EPC STORMWATER REVIEW COMMENTS
IN ORANGE BOXES WITH BLACK TEXT

PRELIMINARY SITE GRADING CONSTRUCTION PLANS
FOR
THE RIDGE AT LORSON RANCH
EARLY OVERLOT GRADING / EROSION CONTROL PLANS

PROJECT:
THE RIDGE AT LORSON RANCH
FONTAINE BLVD, WALLEYE DR
COLORADO SPRINGS, COLORADO

COVER SHEET
EARLY GRADING AND
EROSION CONTROL PLAN

LEGEND

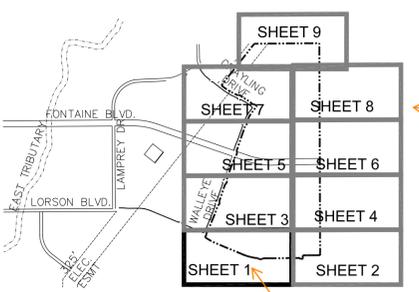
Show "MU" on Legend.

Text likely from a previous submittal. I don't think there is a school adjacent to this filing. If that is the case, remove note.

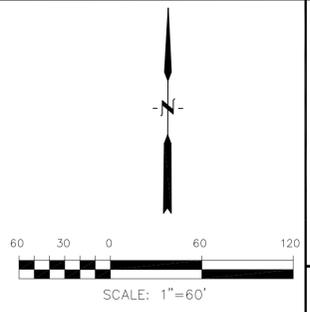
grid shown on sheet index does not match areas shown on plans. Revise sheet index or plan viewports so they match for clarity (C.1 and C.2 are offset for example)

revise sheet index to be C4.1 through C4.9 format for clarity.

Since the area tributary to this is >1ac, a sediment basin is necessary. Notate or show where water discharged from the basin will go. Is it into the adjacent existing street and then to inlets? Typical comments for almost all sediment traps shown on plans.

SHEET NUMBER C4.3

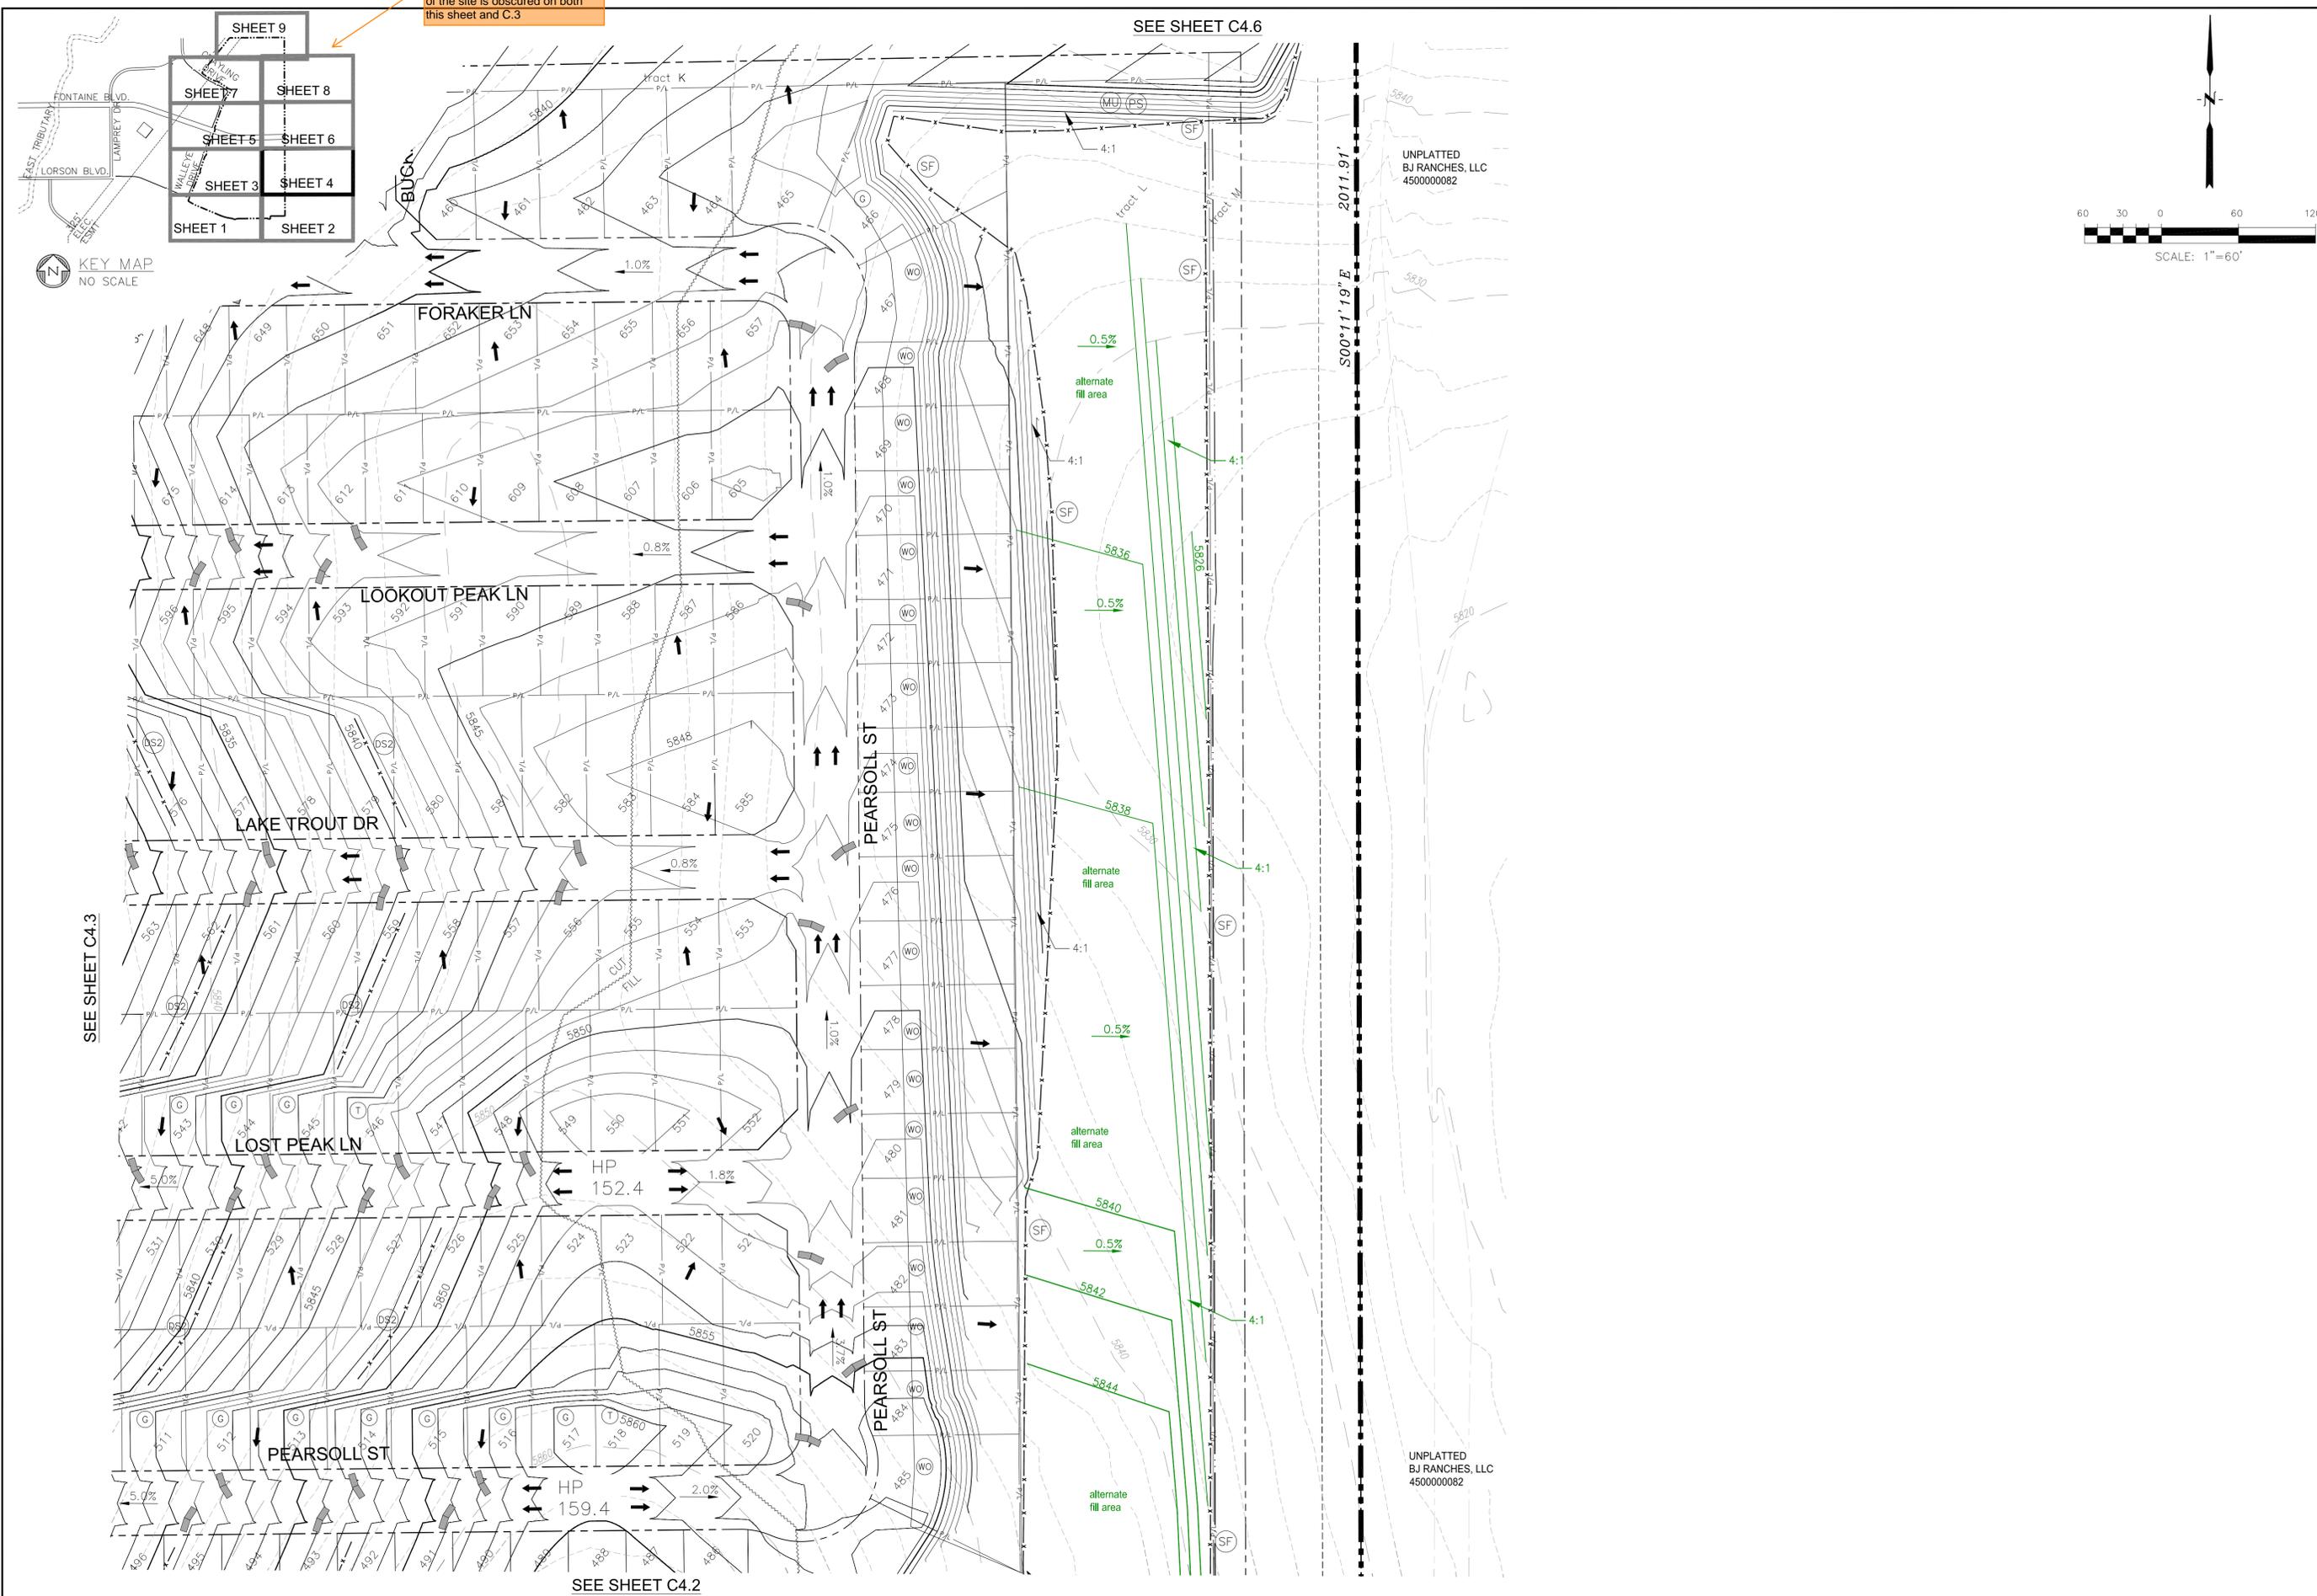
Show/label fence, barricade, or VTC here, depending on if it will be used for construction access or not.

Sediment traps are not sufficient for this application. According to MHPD Detail SC-8, they are for disturbed tributary areas <1ac. For >1ac, a sediment basin is more appropriate. Calculate and show approx tributary area.

If you decide to go with TSB's, provide details of TSB, including riser pipe perforation sizing, number of rows, required volume, and tributary area to the sediment basin.

DATE: MARCH 26, 2021
PROJECT NO. 100.064
SHEET NUMBER C4.5
TOTAL SHEETS: 19

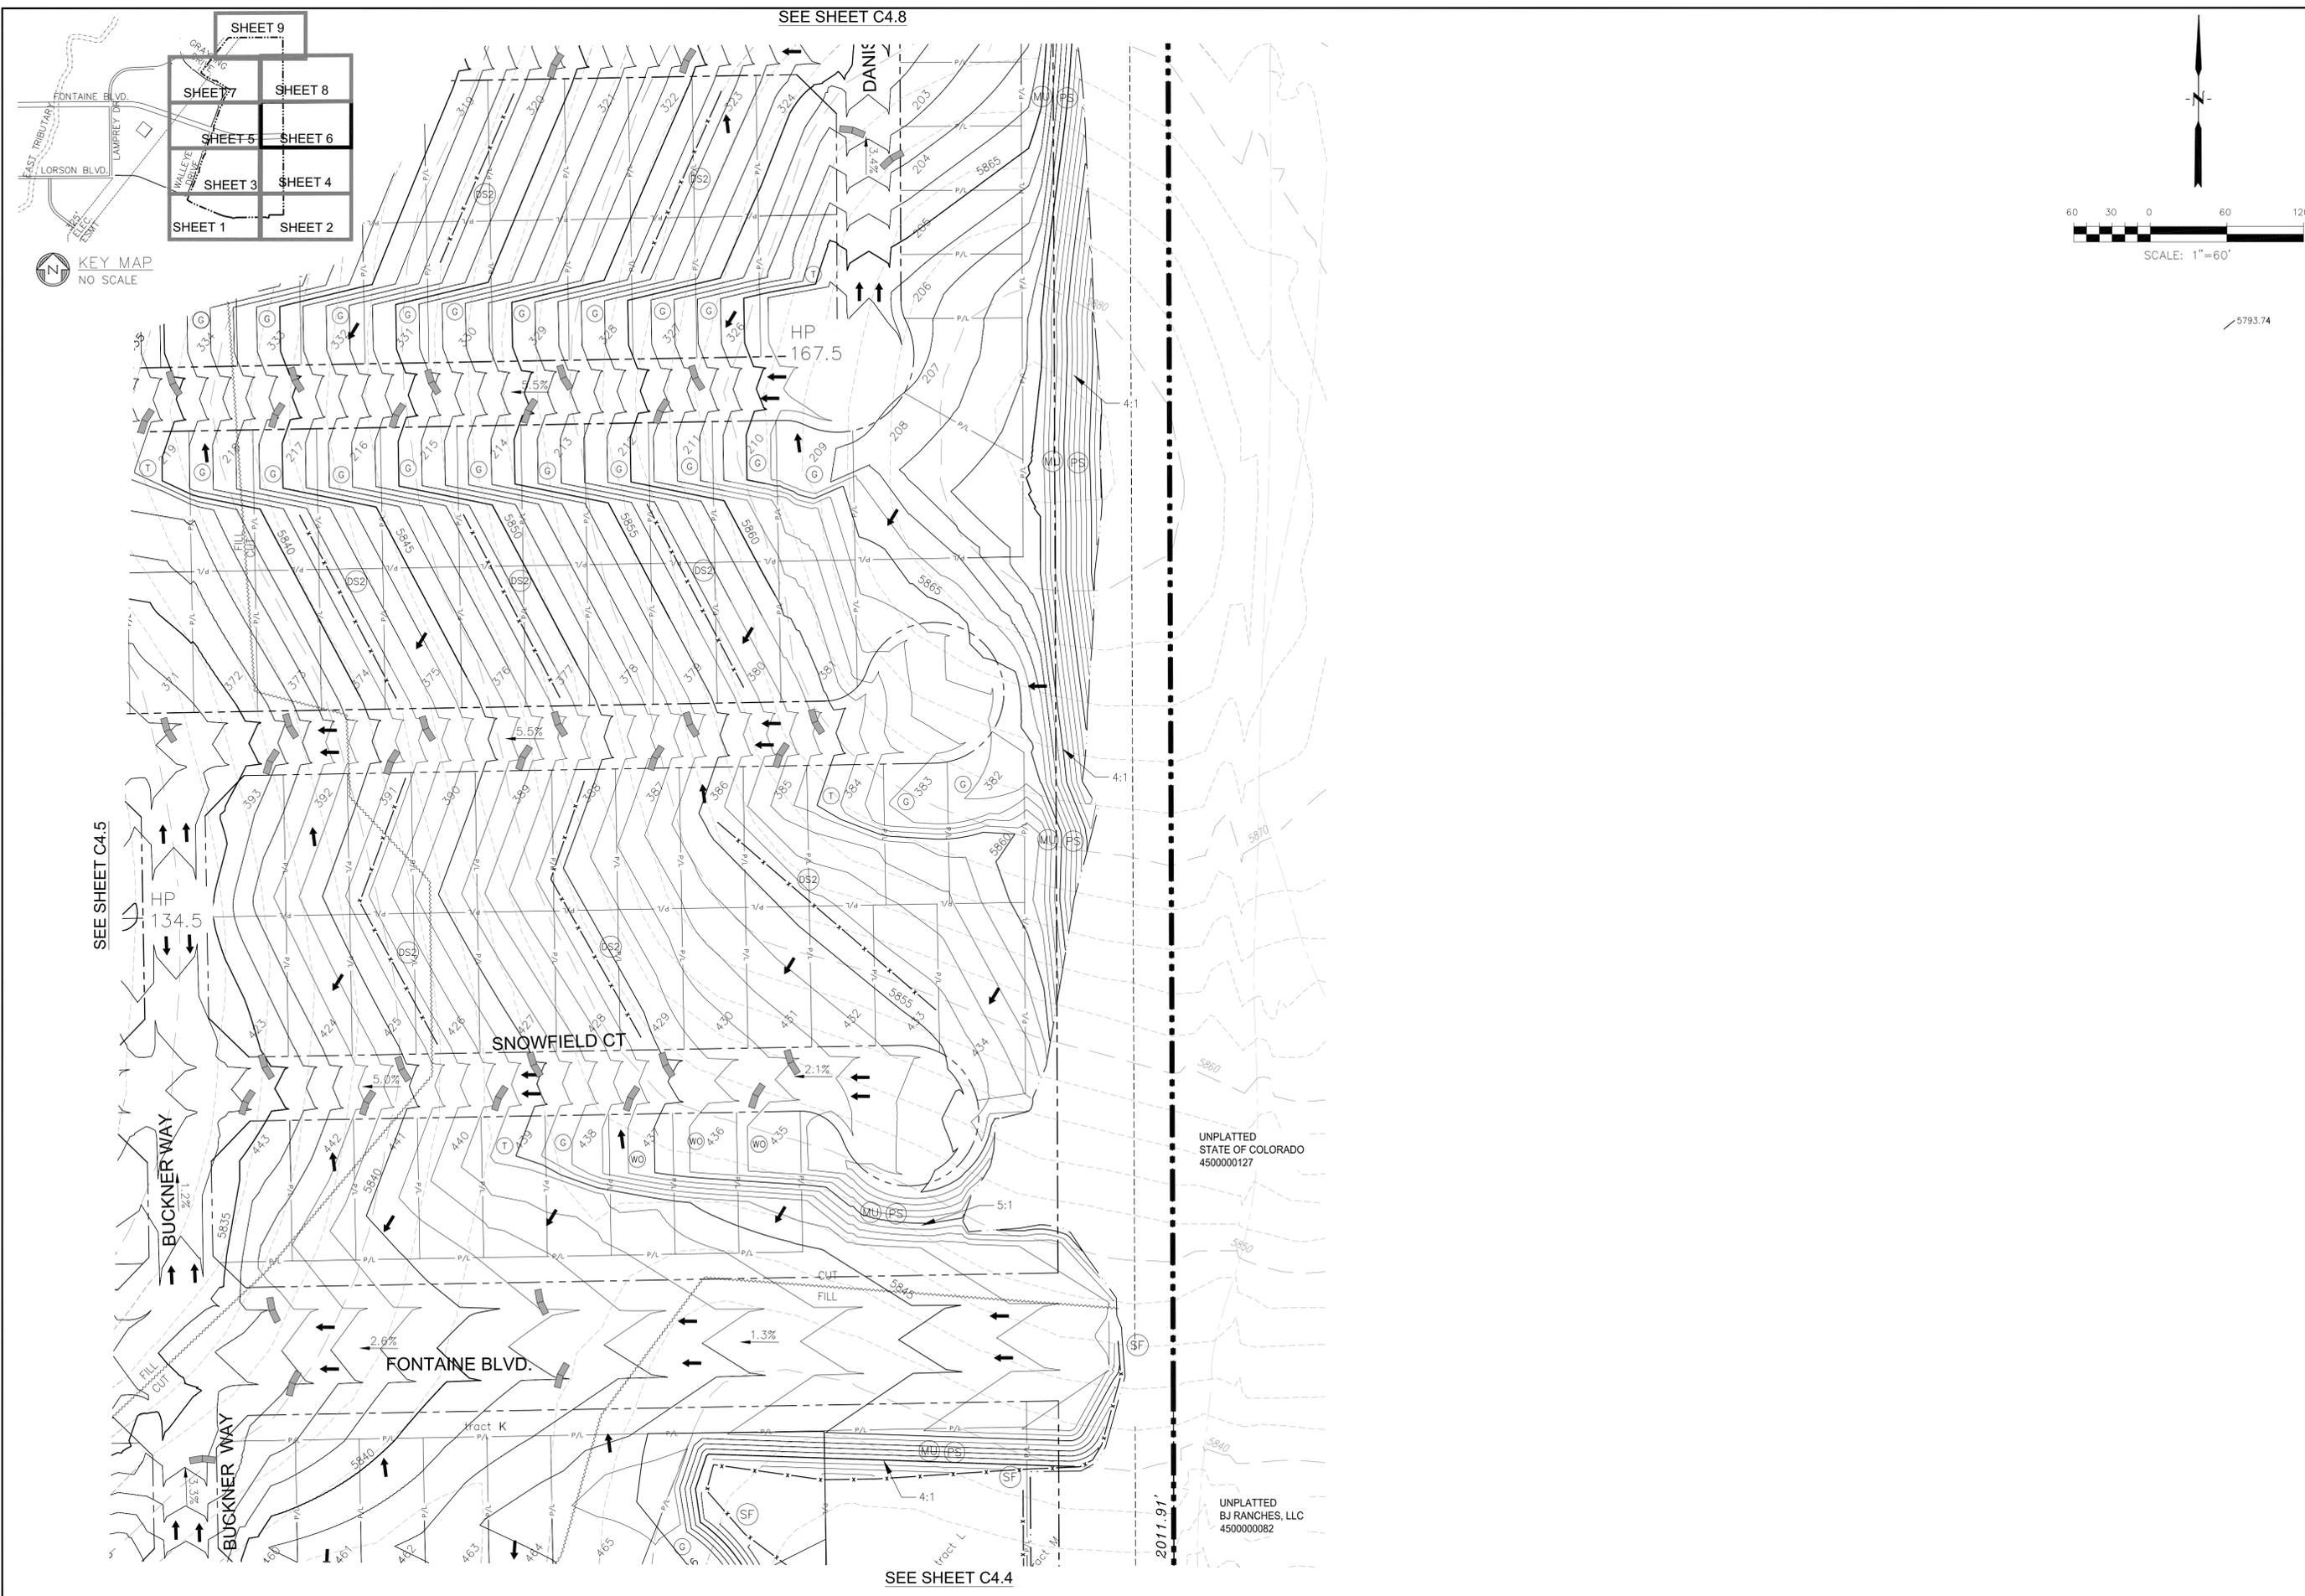
For all TSB's, show contours and provide details including riser pipe perforation sizing, number of rows, required volume, and tributary area to the sediment basin.

Since the area tributary to this is >1ac, a sediment basin is necessary. Noteate or show where water discharged from the basin will go. Is it into the adjacent existing street and then to inlets?

Show/label fence, barricade, or VTC here, depending on if it will be used for construction access or not.

Sediment traps are not sufficient for this application. According to MHFD Detail SC-8, they are for disturbed tributary areas <1ac. For >1ac, a sediment basin is more appropriate. Calculate and show approx tributary area.

Show TSB outlet flowing to the TSB just to the SW at the SS pipe inlet via piping or a swale.

Similar to the north side of Fountain Blvd, consider putting a TSB here at the SS tie-in and route flow from adjacent LP's (where two other TSB's are currently shown) and remove those two TSB's.
